Groundwater Application Review Summary Form

Application # G- 18595

To: Kristopher Byrd, Well Construction and Compliance Section Manager
From: Joel Jeffery, Well Construction Program Coordinator
Subject: Review of Water Right Application G-18595
Date: August 31, 2018

TO: Water Rights Section Date 08/30/2018
 FROM: Groundwater Section Darrick E. Boschmann
 Reviewer's Name
 SUBJECT: Application G-18595 Supersedes review of N.A.
 Date of Review(s)

Figure 2: Hydrograph for LAKE 1633.

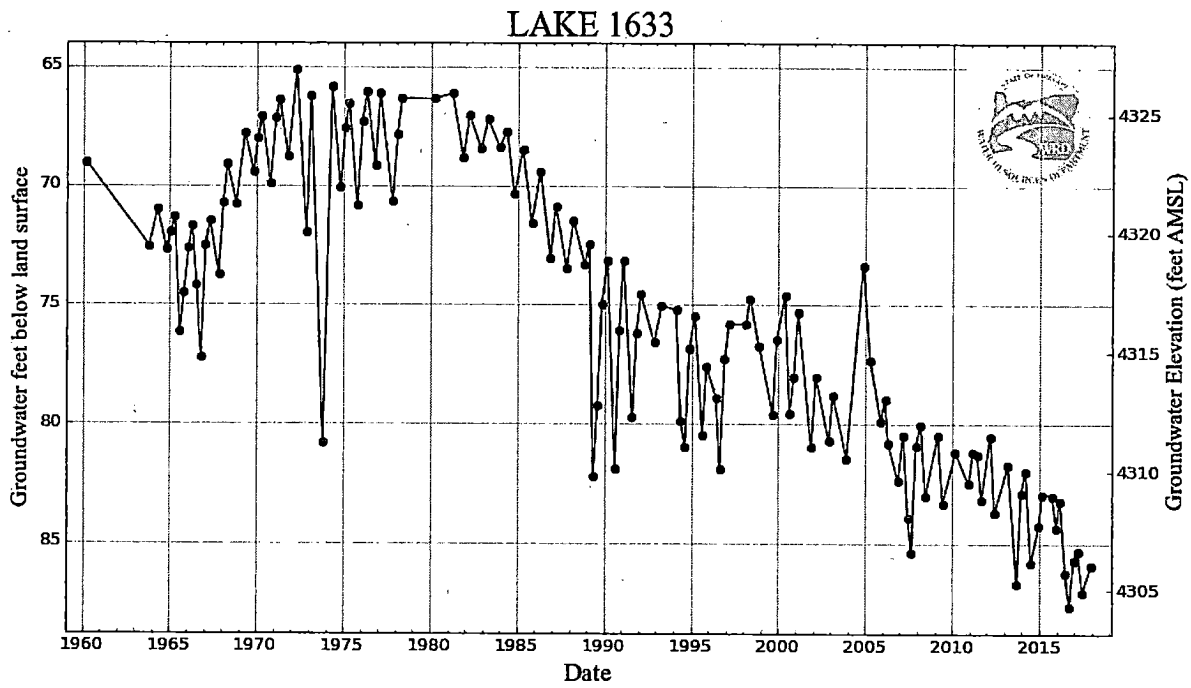
The nearest state observation well to the proposed location is State Observation Well 374 (LAKE 1633) located ~1.5 miles to the northeast which has a period of record from 1963 to 2017. The long term annual groundwater level trend in this well indicates an overall year-year water level decline of about 19 feet from 1980 to 2017, or roughly 0.5 feet per year since 1980. Formation descriptions on the well log for LAKE 1633 indicate the well is completed in the basin fill sediments.

Figure 3: Reported permit condition water level data for LAKE 52683.

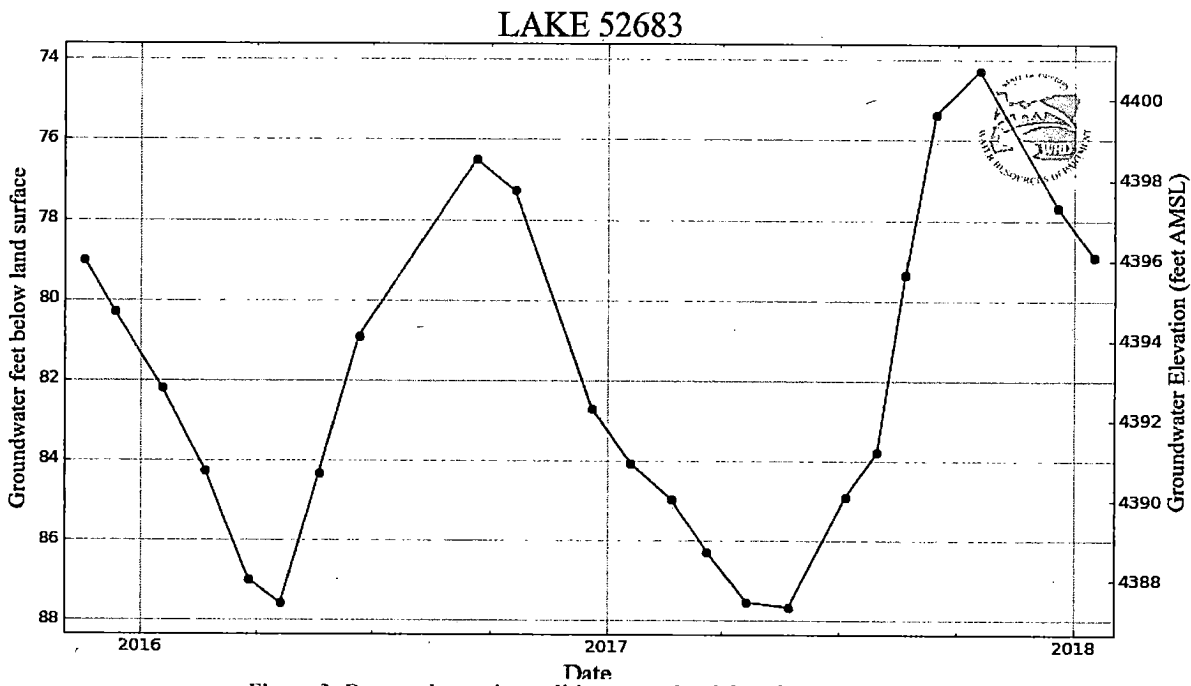
Observation well LAKE 52683 (permit condition obs well under permit G-17434; 380ft TD/115°F) located within the project area has a period of record from 2015 to 2018. No long term annual groundwater level trend can be identified in this well due to the short period of record; however there are no immediate signs of water level decline. Formation descriptions on the well log for LAKE 52683 indicate the well is completed in the basin fill sediments.

Figure 4: Reported permit condition water level data for LAKE 1628.

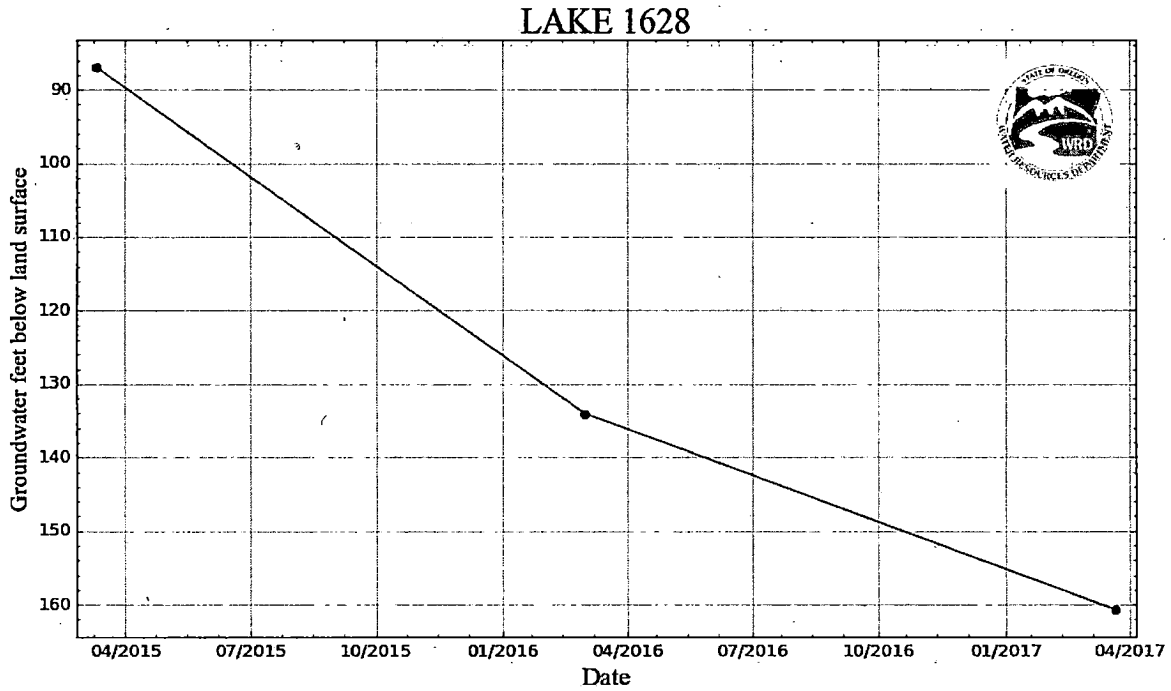
March static water levels reported to the department under the permit condition program for LAKE 1628 (“Little Hot Well”; 432 ft TD/175°F) indicate a 73 foot water level decline over the period 3/2015 – 30/2017. March static water levels reported to the department under the permit condition program for LAKE 52506 (“SVE#4” industrial use/cooling water; 378 ft TD/118°F) indicate a 20 foot water level decline over the period 3/2015 – 3/2016. These reported records suggest significant rates of decline in the immediate vicinity of proposed production well LAKE 52529 (see following paragraphs).

It is clear from the supplemental data that the “static” water level reported to the department for 03/01/2016 and 03/22/2017 for LAKE 1628 was affected by a recent period of pumping either in that well, or in LAKE 52506, or possibly both, and that the water level reported represents a pumping or recovery/rising level, rather than a true static water level which could be directly compared to the March level from the previous year. Due to the year-round pumping/recovery cycles at this well it is difficult to determine whether or not any year-to-year water level declines are occurring, however since regular pumping began in 2015 the well has never fully recovered to its pre-2015 static water levels, and the full record does seem to indicate that declines may be occurring.

Figure 5: Reported permit condition water level data for LAKE 52506.

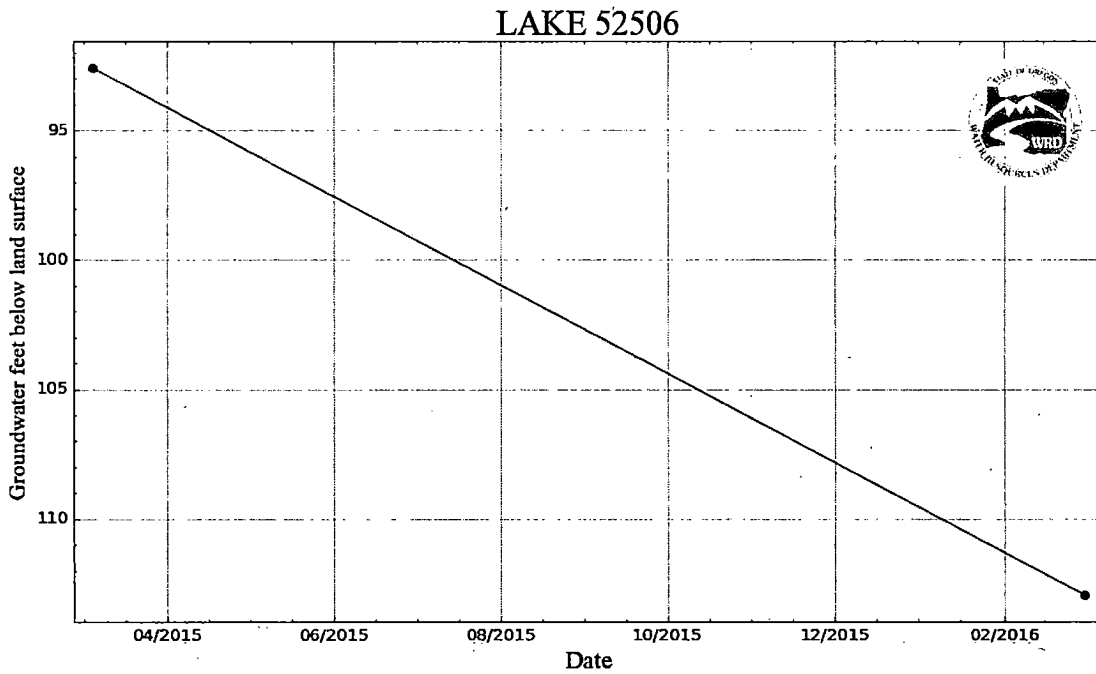
It is clear from the supplemental data that the “static” water level reported to the department for 03/01/2016 for LAKE 52506 was affected by a recent period of pumping in that well; and that the water level reported represents a pumping or recovery/rising level, rather than a true static water level which could be directly compared to the March level from the previous year. The period of record for LAKE 52506 provided in the supplemental data covers 05/12/2014 – 01/16/2018. Due to the year-round pumping/recovery cycles at this well it is difficult to determine whether or not any year-to-year water level declines are occurring; although from October 2014 to October 2017 (two periods for which there appears to be no direct pumping influence), the record does indicate approximately 7-8 feet of overall decline; or approximately 2.5 ft/yr.

Figure 8: Supplemental data provided by the applicant - LAKE 52530.

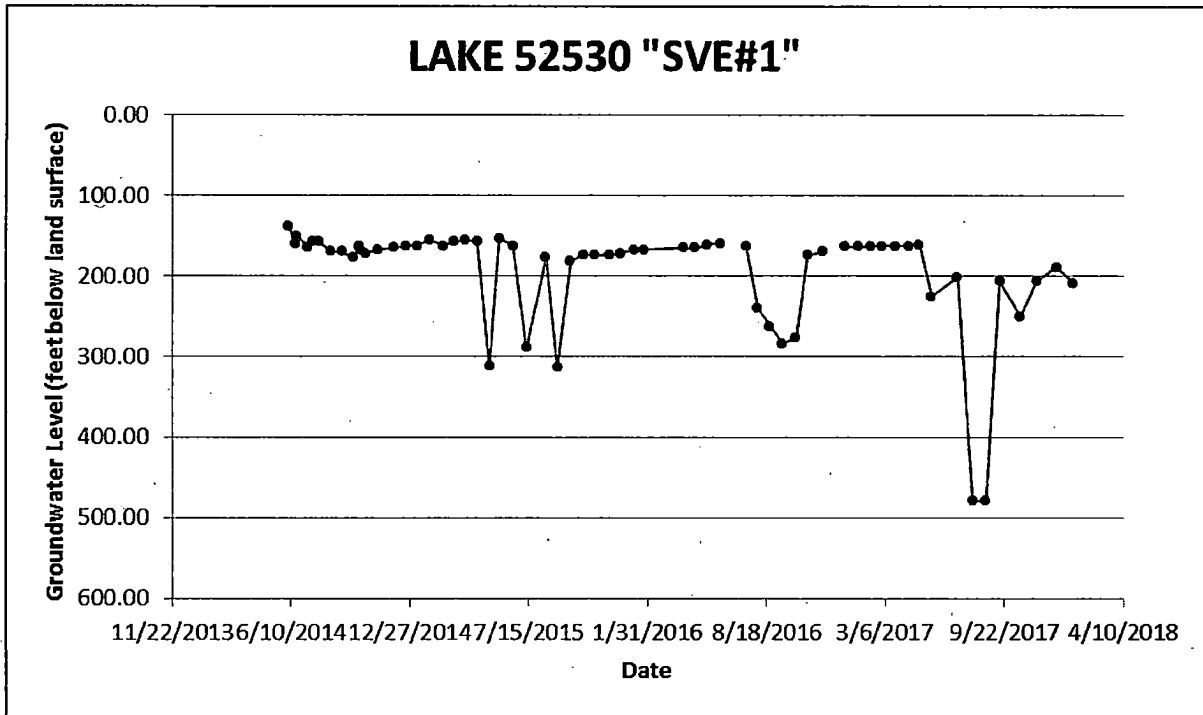
Proposed production well LAKE 52530 (SVE#1) has a period of record from 6/6/2014 to 1/16/2018. Due to the year-round pumping/recovery cycles at this well it is difficult to determine whether or not any year-to-year water level declines are occurring, however there are no apparent signs of significant water level declines.

Figure 9: Supplemental data provided by the applicant - LAKE 52529.

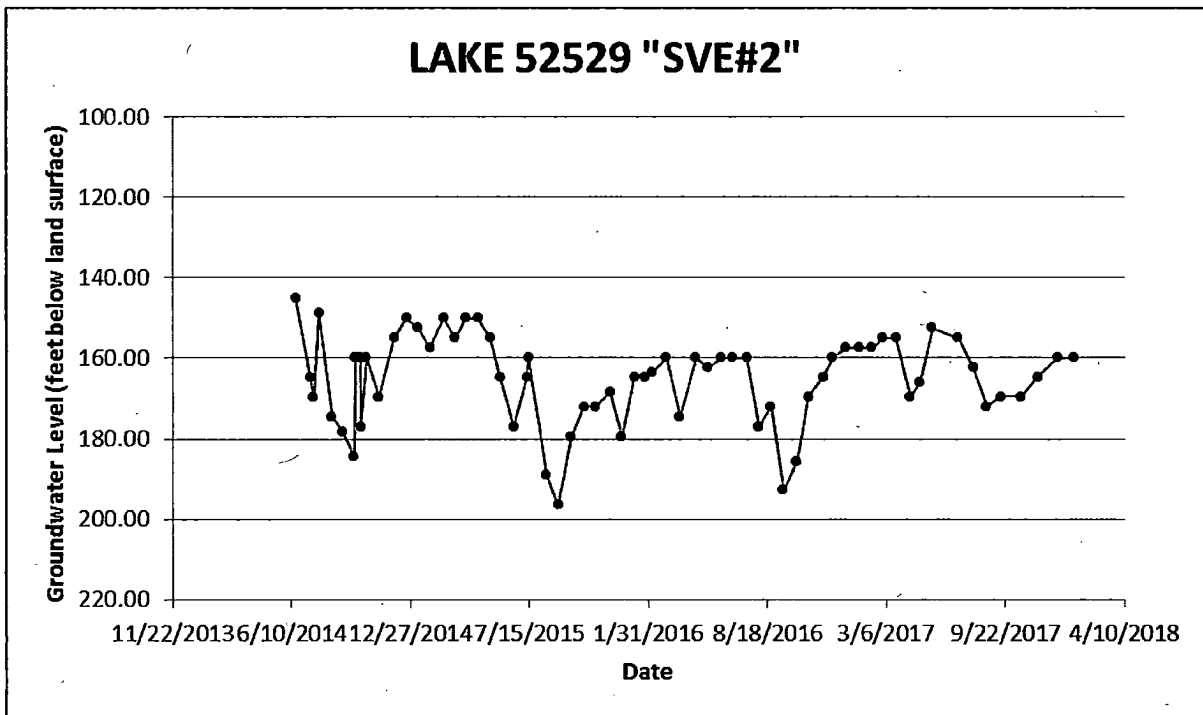
Proposed production well LAKE 52529 (SVE#2) has a period of record from 6/17/2014 to 1/16/2018. Due to the year-round pumping/recovery cycles at this well it is difficult to determine whether or not any year-to-year water level declines are occurring, however there are no apparent signs of significant water level declines.

Figure 10: Supplemental data provided by the applicant - LAKE 1638.

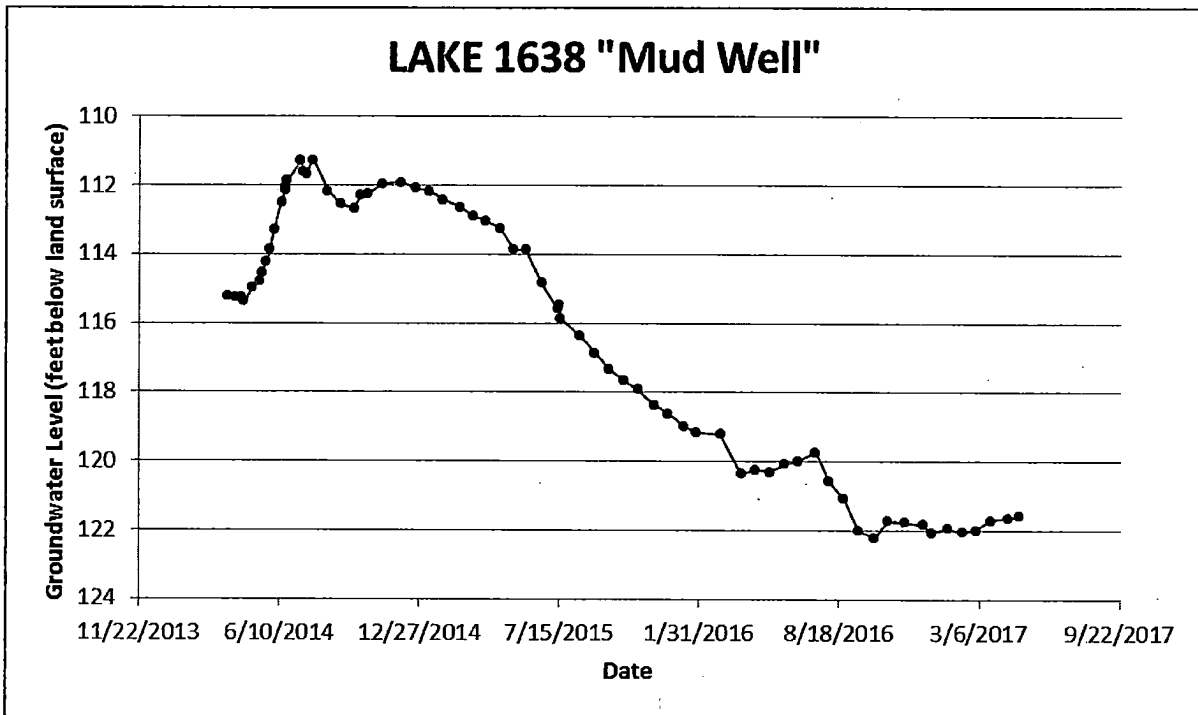
LAKE 1638 (“Mud Well”; unused irrigation well/livestock?; 775 ft TD/120°F) has a period of record from 3/28/2014 to 5/2/2017. The hydrograph for this reportedly unused irrigation well shows a clear and consistent decline trend from 2014 through spring of 2017 of approximately 6-10 feet over the period of record; or approximately 2 – 3.3 ft/yr. Formation descriptions on the well log for LAKE 1638 indicate the well is completed in the basin fill sediments.

Figure 11: Supplemental data provided by the applicant - LAKE 1625.

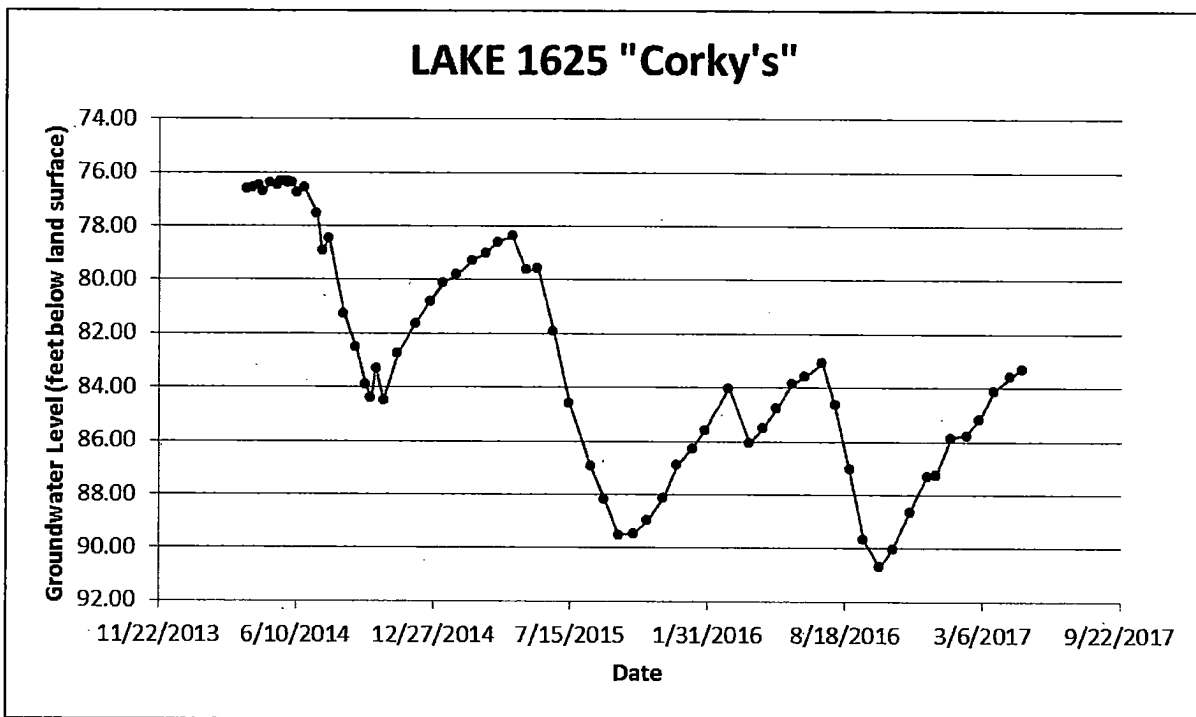
LAKE 1625 (“Corky’s”; unused irrigation well; 610 ft TD/175°F) has a period of record from 3/28/2014 to 5/2/2017. The hydrograph for this reportedly unused irrigation well shows a clear and consistent decline trend from 2014 through spring of 2017 of approximately 6-7 feet over the period of record; or approximately 2 ft/yr. Formation descriptions on the well log for LAKE 1625 indicate the well is completed in the basin fill sediments.

Figure 12: Supplemental data provided by the applicant - LAKE 1637.

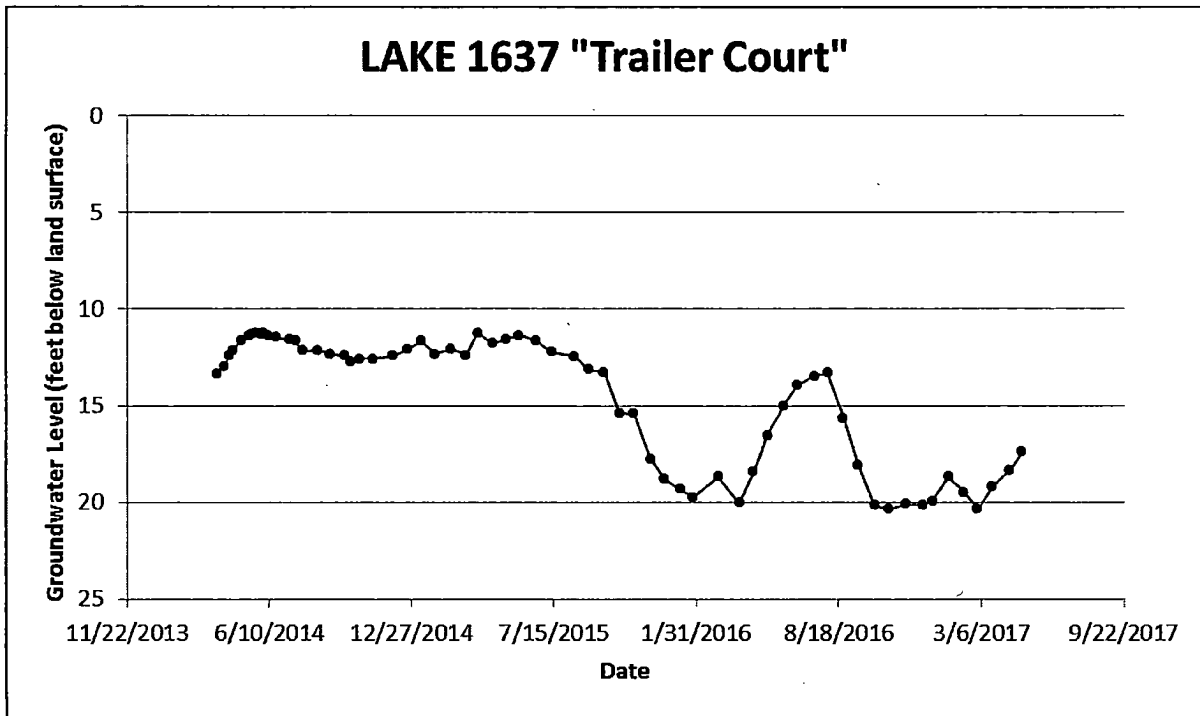
LAKE 1637 (“Trailer Court”; livestock; 153 ft TD/~75°F) has a period of record from 3/28/2014 to 5/2/2017. Due to the year-round pumping/recovery cycles at this well it is difficult to determine whether or not any year-to-year water level declines are occurring. Formation descriptions on the well log for LAKE 1637 indicate the well is completed in the volcanic rock unit.

Figure 13: Supplemental data provided by the applicant - LAKE 4278.

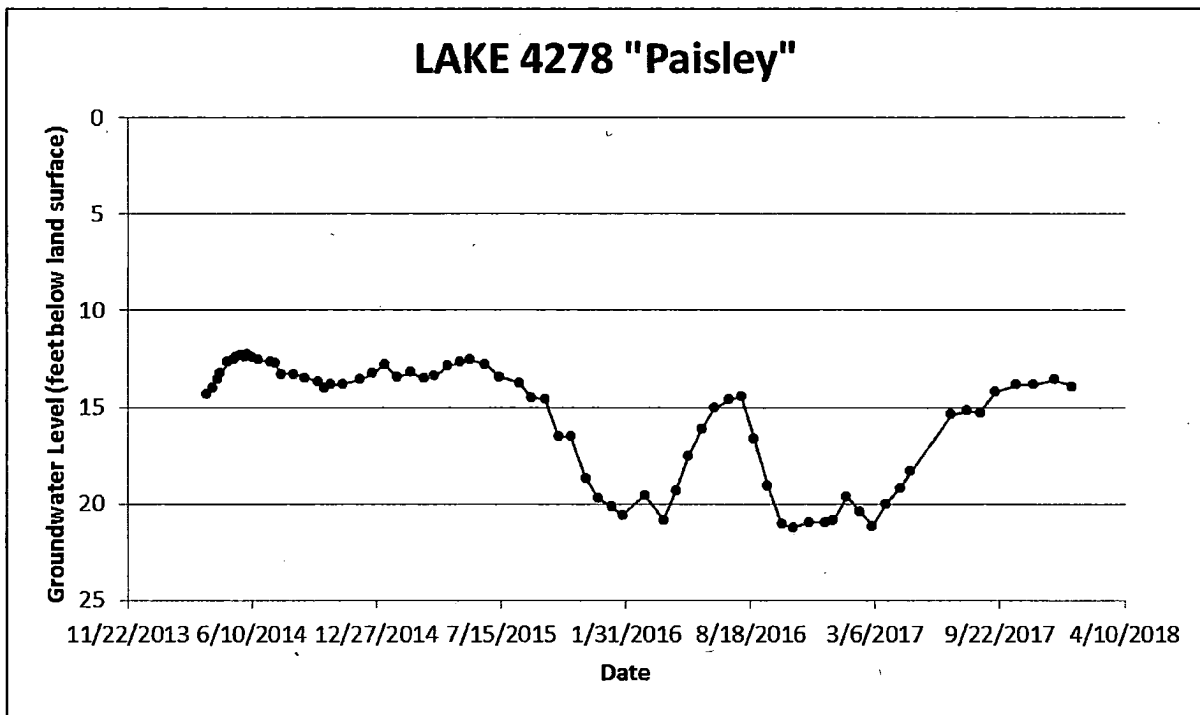
LAKE 4278 (“Paisley”; unused; 515 ft TD/115°F) has a period of record from 3/28/2014 to 1/16/2018. The hydrograph for this well does not indicate any apparent signs of significant water level declines. Formation descriptions on the well log for LAKE 4278 indicate the well is completed in the volcanic rock unit.

Figure 14: Supplemental data provided by the applicant - LAKE 51059.

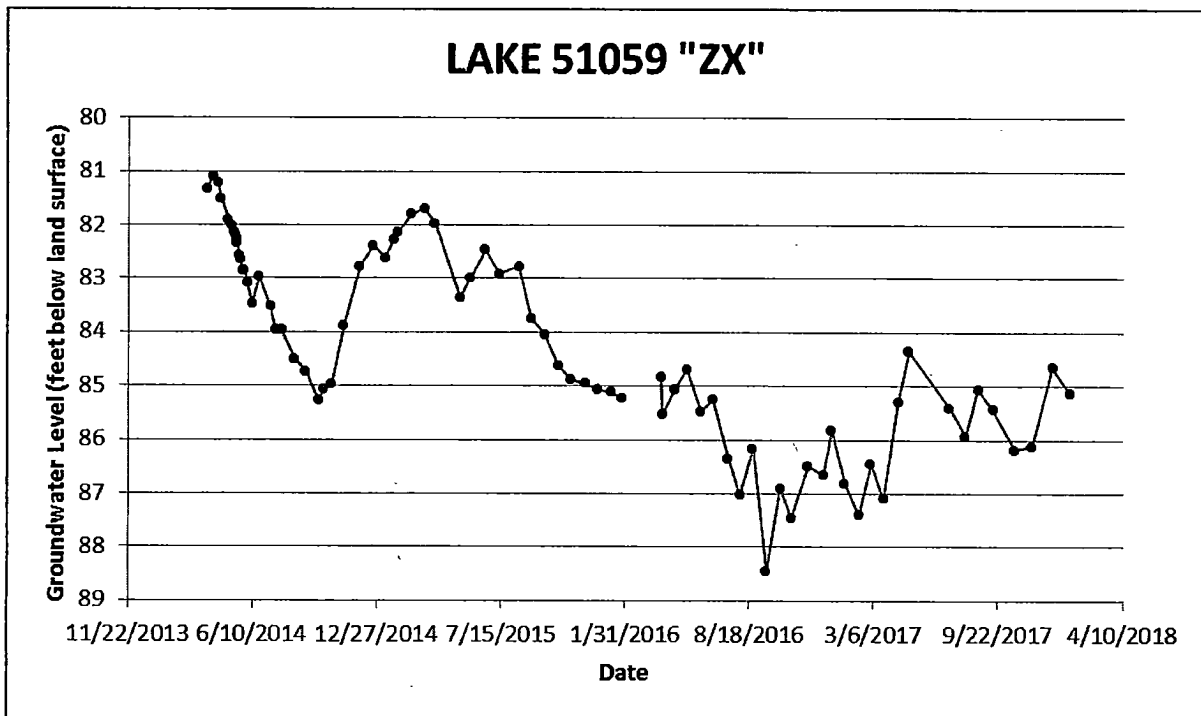
LAKE 51059 (“ZX”; unused; 1412 ft TD/78°F) has a period of record from 3/28/2014 to 1/16/2018. The hydrograph for this well indicates a decline trend from spring of 2014 through spring of 2017 of approximately 3.25 feet over the period of record; or approximately 1 ft/yr. Formation descriptions on the well log for LAKE 51059 indicate the well is completed in the volcanic rock unit.
